TO: Planning and Zoning Commission
FROM: Evann Martin, Assistant Planner
DATE: August 4, 2020
RE: Hy-Vee Fast & Fresh – Site Plan

RE: Hy-Vee Fast and Fresh Site Plan (SE 37th and Hwy 141)

The Development Services Department is in receipt of a proposed Site Plan for Hy-Vee Fast and Fresh. Based on the review of the provided submittal materials, staff have the following comments:

HY VEE FAST AND FRESH
3605-3505-3455 GATEWAY DRIVE, GRIMES, IA
DEMOLITION PLAN

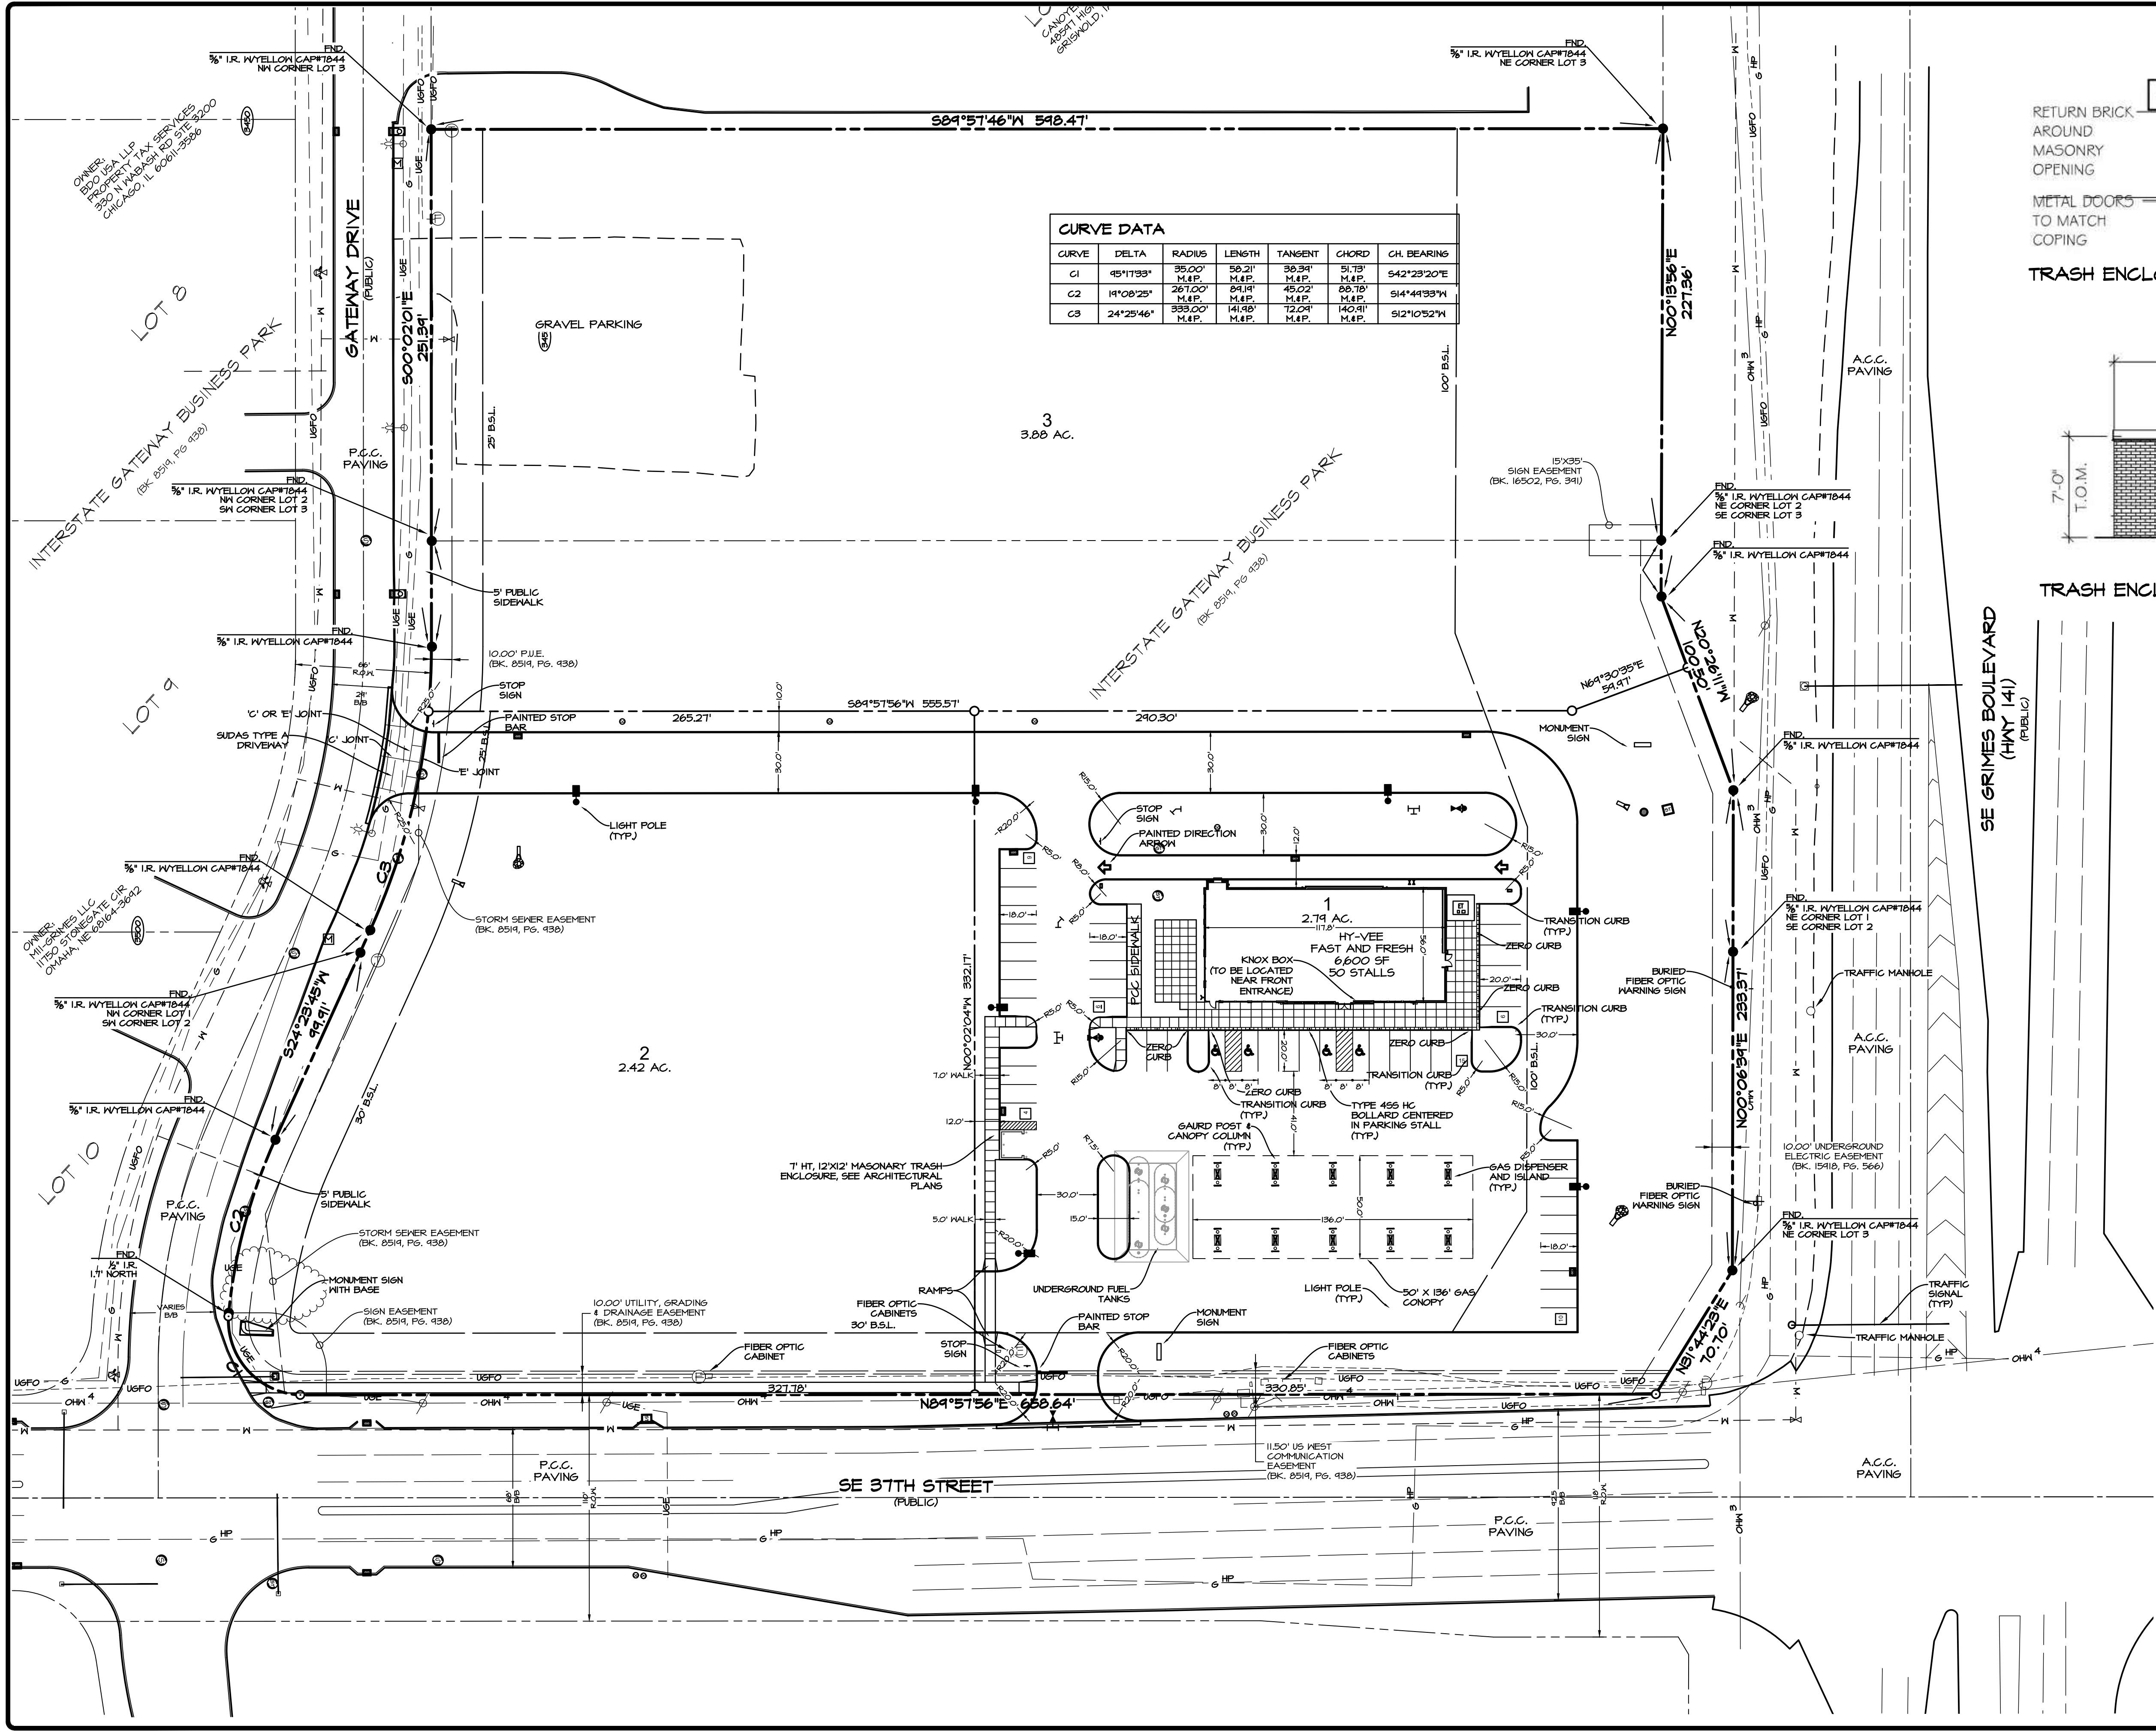
1. ~~Staff is not supportive of the location of the RI-RO as shown. The proximity to HWY 141 is problematic due to the traffic volumes and traffic type. The RI-RO should be moved back to just west of the Lot 1 and 2 property line. Staff is evaluating if a turn lane is necessary. The RI-RO for QT is not a comparable example. If proposed today, it would also be challenged due to the distancing. Staff is not supportive of the location and is asking that if desired, that it be moved back as originally proposed in the conceptual plan provided by Hy-Vee. Staff would consider the RI-RO without a turn lane if it was positioned further back.~~

2. ~~Based upon the above, staff questions if it is more practical to locate the F&F on Lot 2.~~
3. ~~Please attempt to align the driveway with the storage facility across SE Gateway.~~

4. ~~Show a 5' sidewalk along SE 37th St. A Petition and Waiver will be required to address the construction of the sidewalk in the future as Lot 2 develops. Show sidewalk to the driveway and nothing further east.~~

5. ~~Please add a pedestrian connection to SE 37th St. Please connect the sidewalk to the building. Staff suggests bringing the sidewalk north passed the dumpster and shifting the landscaping island to bring the sidewalk across to the building. Another option~~

~~would be to provide connection from the east side of the driveway straight north through the landscape island to the building.~~

- ~~6. The vehicle movement on the south side of the site appears to be potentially conflicting. Staff would suggest shifting the site north to align the driveway on the south side of site. Will resolve itself with the relocation of the RI RO.~~
- ~~7. One landscape island is required per 12 parking spaces. The parking area along the front of the building exceeds this requirement.~~
- ~~8. Please provide a detail for the decorative jointing pattern for the sidewalk to the east and north of the proposed building.~~
- ~~9. Add stop bars and traffic signage. Please add stop bar pavement markings to site plan.~~
- ~~10. The Knox Box noted shall be installed near the front entrance to the building, and shall be obtained by going to www.knoxbox.com.~~
- ~~11. The dumpster cannot face Hwy 141 and will need to be relocated to the north or west elevation.~~

1 SOUTH ELEVATION

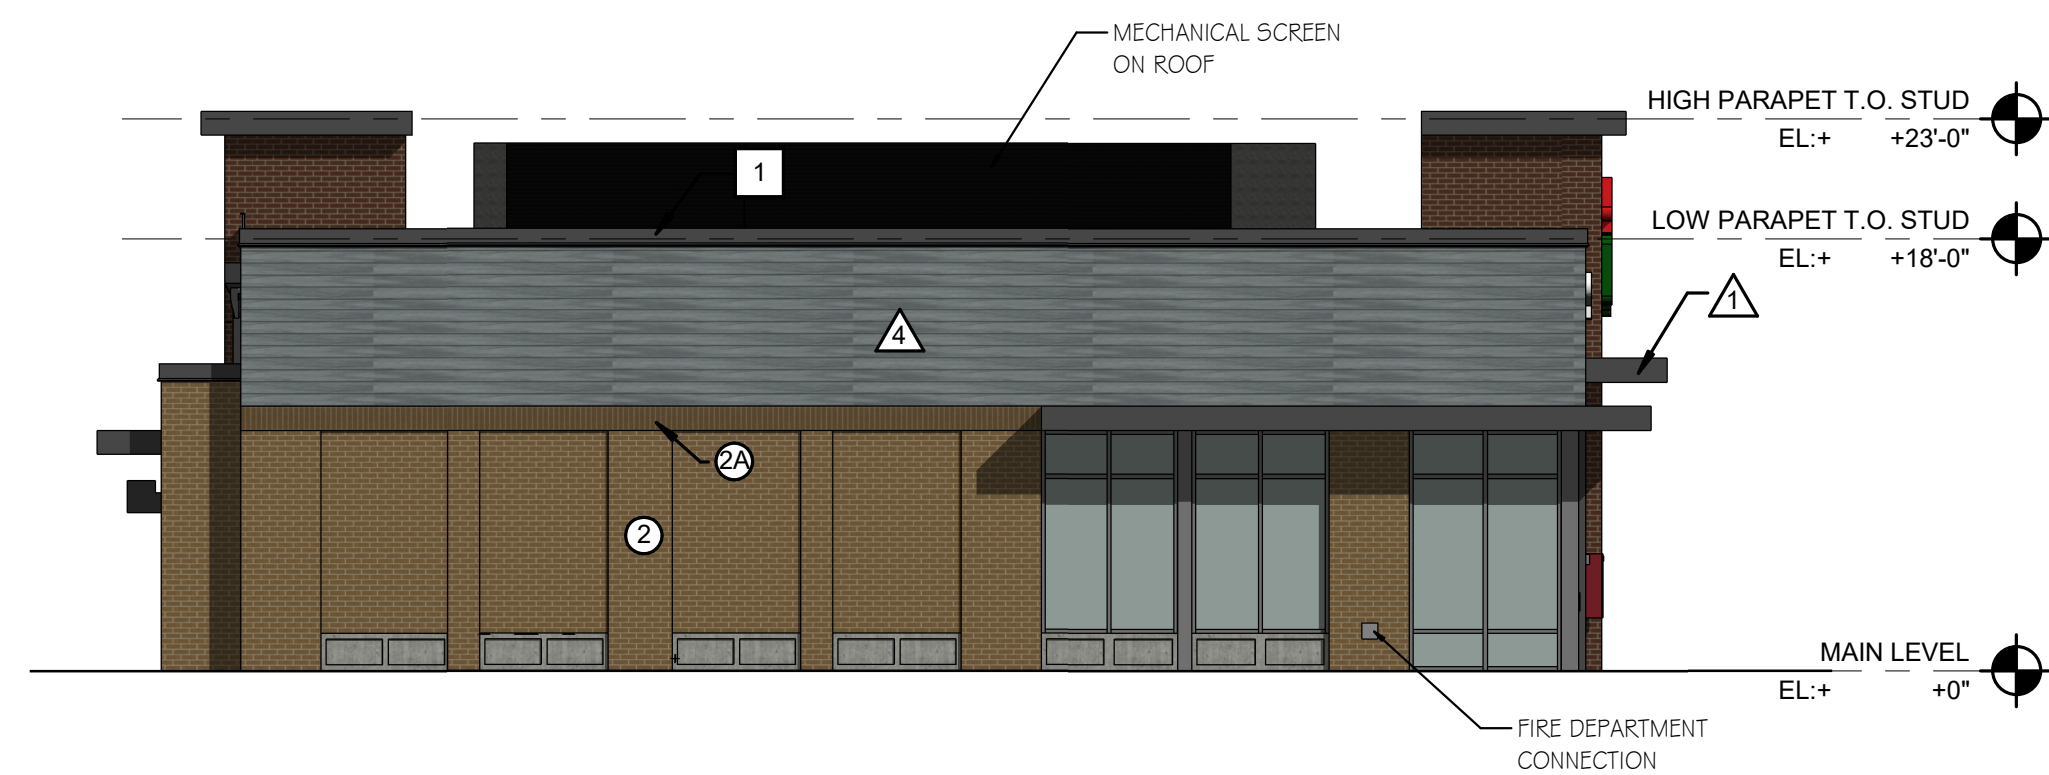
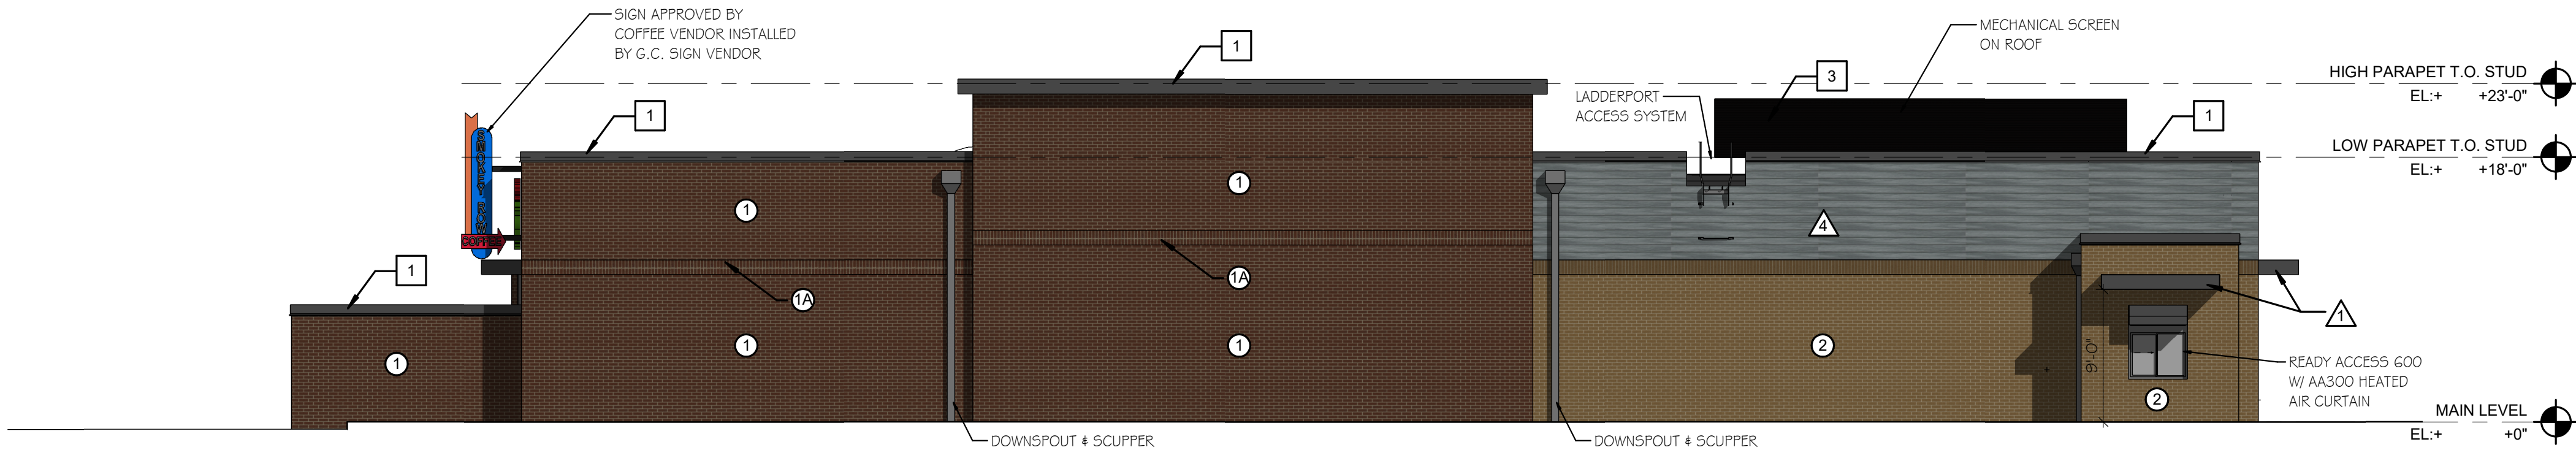
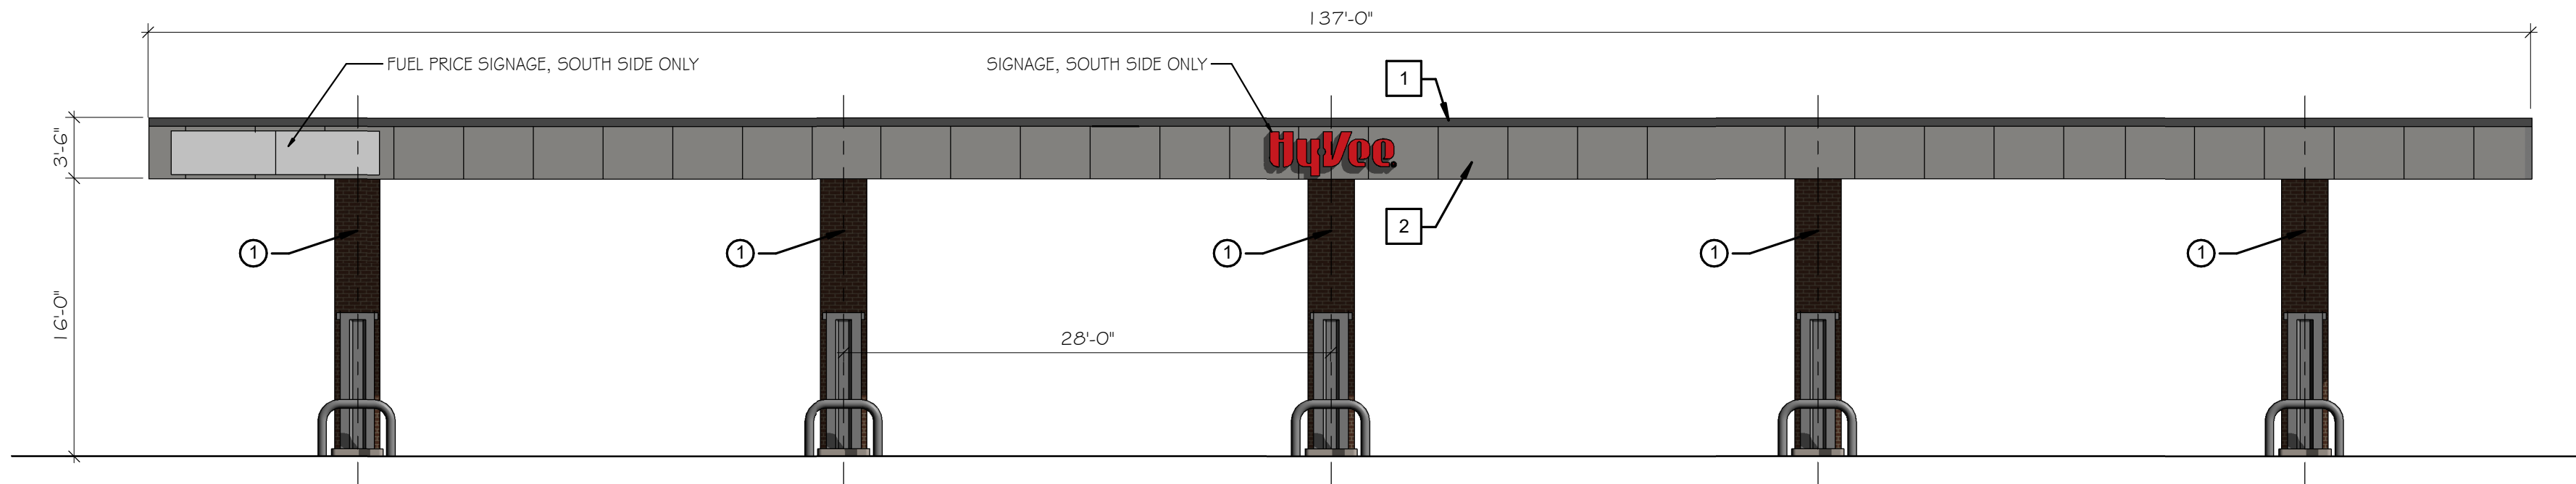
1. ~~Provide calculations showing the percentage of brick vs cladding.~~
2. Provide calculation showing the percentage of glazing on the south and east building façade. Since the building orientation has changed, the new east side of the building must be at least 20% glazing. Please provide the calculation on the elevation sheet.

- ~~3. No blank wall area or façade shall exceed 30 feet in horizontal or vertical direction. Staff asks that additional detail be added to the west elevation to satisfy this requirement such as bump-outs similar to what is shown on the south elevation.~~

4. Provide a list of the 5 design elements illustrated in the façade design per the Hwy 141 Zone 1 regulations. Please add the list from the response letter to the elevation sheet.

6. Up lighting is required on the building faces adjacent to public ROW. Please provide up lighting location and cut sheets for the fixtures. Please provide lighting fixture cut sheets.
